WRL Ref: WRL2021004 JTC LR20210514

## **DRAFT Newport SLSC coastal hazard peer review**

- Horton (2020a), "*Coastal Engineering Report and Statement of Environmental Effects for Buried Coastal Protection Works at Newport SLSC*", prepared by Horton Coastal Engineering Pty Ltd for Adriano Pupilli Architects, Issue 2 dated 16 November 2020.

**Figure 1: Observed sea level rise at Fort Denison (Watson, 2020)**

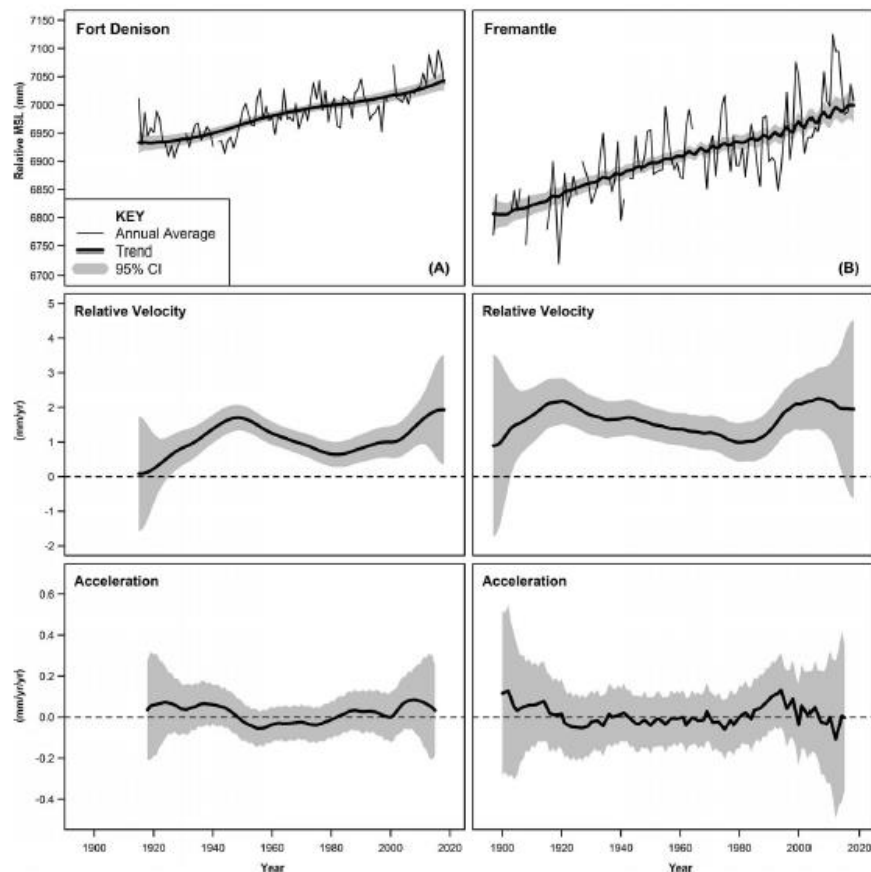
The analysis of long term change, which found that there is not a detectable trend is accepted by WRL. We note that during the analysis period of long term change (1941 or 1951 to 2018), mean sea level for Sydney has increased by 1 to 2 mm per year (Watson, 2020). Figure 5 of Watson (2020) is reproduced as Figure 1 in this WRL letter.

That is, Newport Beach has been broadly stable with sea level rise of 1 to 2 mm per year, therefore the predicted future response (recession) to sea level rise could be discounted by the quantum of sea level rise which occurred but produced no recession. Neither the Horton reports nor this WRL review are a detailed processes study, but an onshore or alongshore feed of sand has been postulated at other locations, noting that sea level rise may outpace this feed in the future.

The estimated sea level rise recession of 13.6 m by 2080 may be an overestimate. This is because the lack of underlying recession over the monitoring period, despite 1 to 2 mm per year of sea level rise, has not been considered. Discounting for the sea level rise that has already occurred (and resulted in no recession) would reduce the recession by 1.9 to 3.8 m.
